NORTHEAST MAINTENANCE SUBSTATION ADDITION TO WICHITA, SEDGWICK COUNTY, KANSAS

RE: S/D- 98-93 - Final Plat of NORTHEAST MAINTENANCE SUBSTATION ADDITION

STAFF REPORT
(One-Step Final Plat)

CASE NUMBER: S/D 98-93 - NORTHEAST MAINTENANCE SUBSTATION
ADDITION

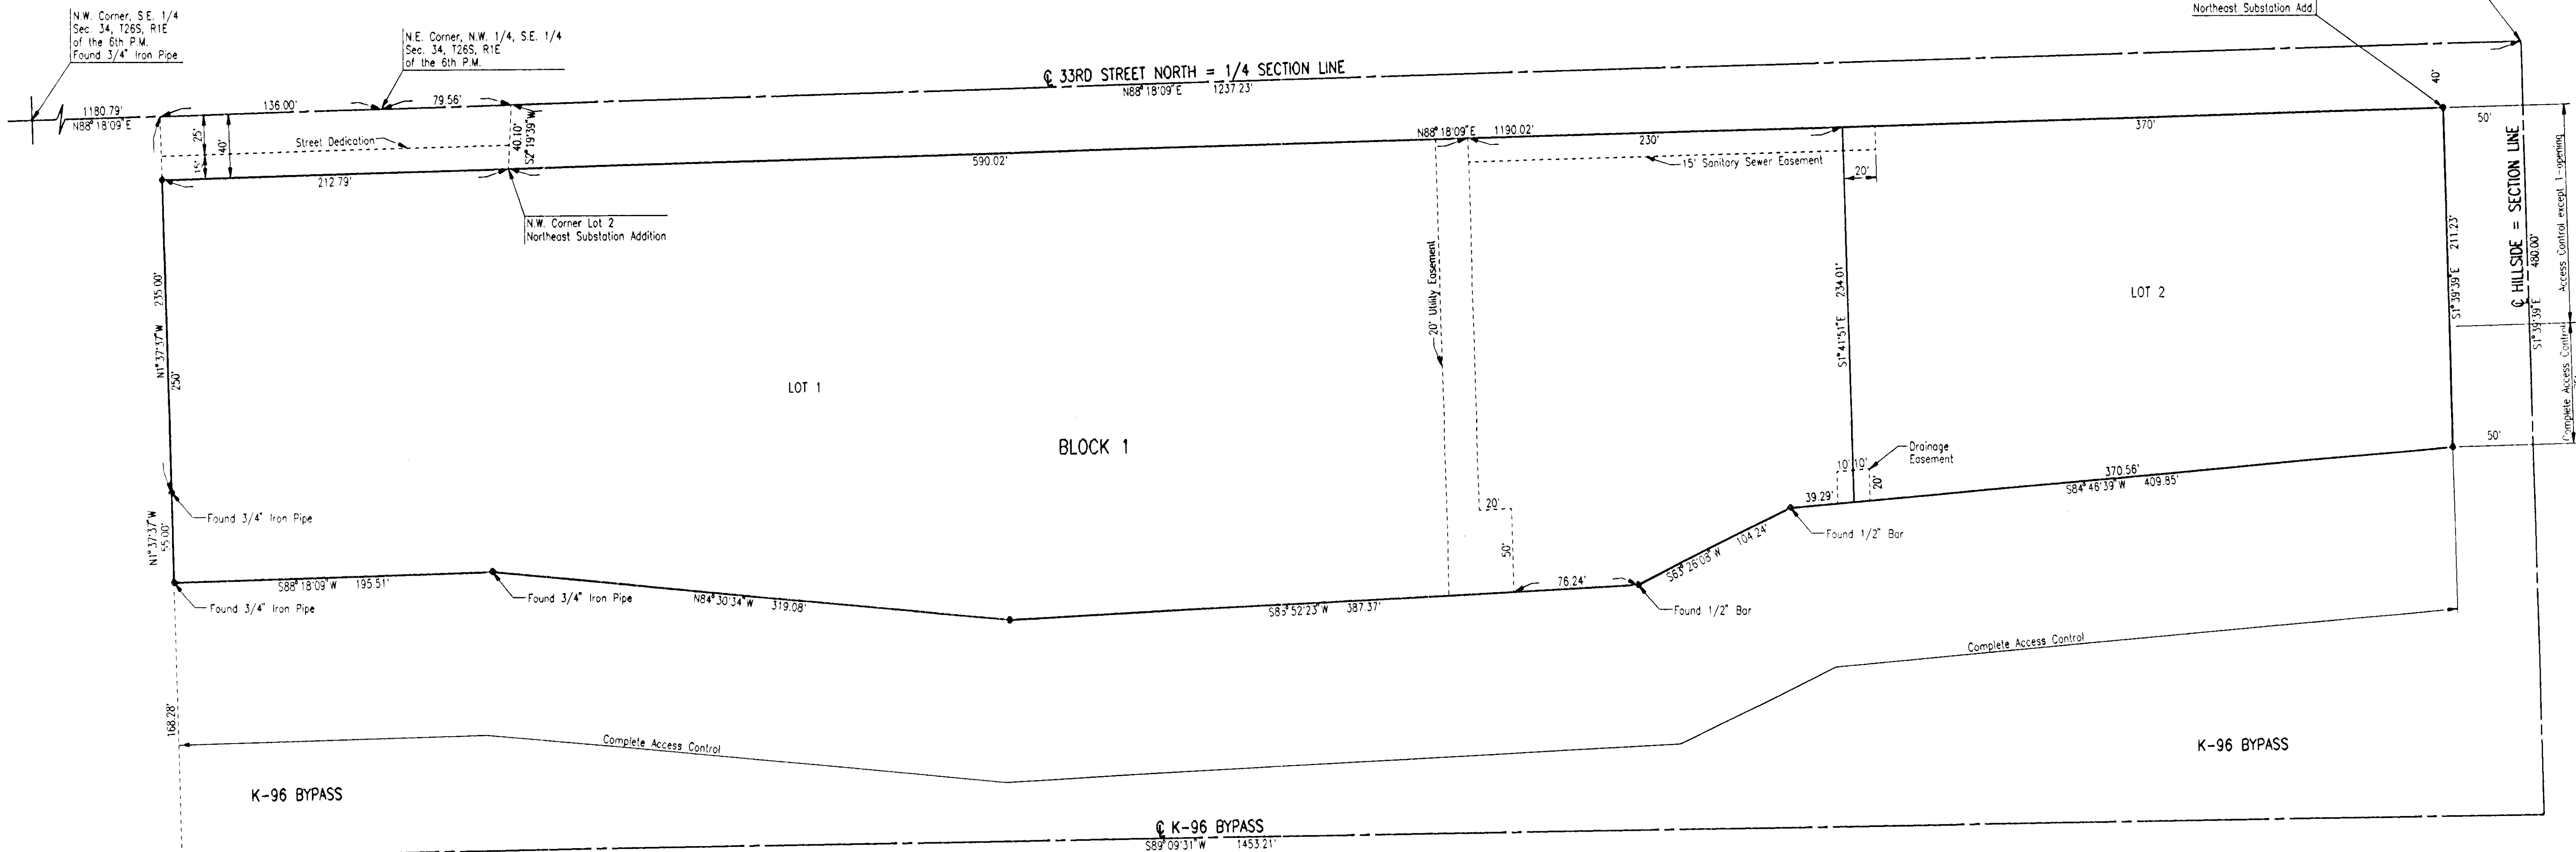
- A. Existing municipal services appear to be available to serve this site. City Engineering needs to verify if any other additional guarantees are required. *A guarantee needs to be provided for sanitary sewer extension to Lot 2.*

- C. City Engineering needs to comment on the status of the applicant's drainage plan. *A cross-lot drainage agreement needs to be established by separate instrument.*

- D. Traffic Engineering needs to comment on the platted access controls. The plat denotes one access opening along Hillside. Access controls dedicated along K-96 need to be referenced on the final tracing.

- E. Since drainage occurs onto K-96, a letter shall be provided from KDOT indicating their agreement to accept such drainage.
- F. The dedication of right-of-way for 33rd St. North needs to be referenced in the plat's text.

- H. Traffic Engineering needs to comment on the need for improvements to Hillside.
- I. The applicant shall install or guarantee the installation of all utilities and facilities which are applicable and described in Article 8 of the MAPC Subdivision Regulations. (Water service and fire hydrants required by Article 8 for fire protection shall be as per the direction and approval of the Chief of the Fire Department.)
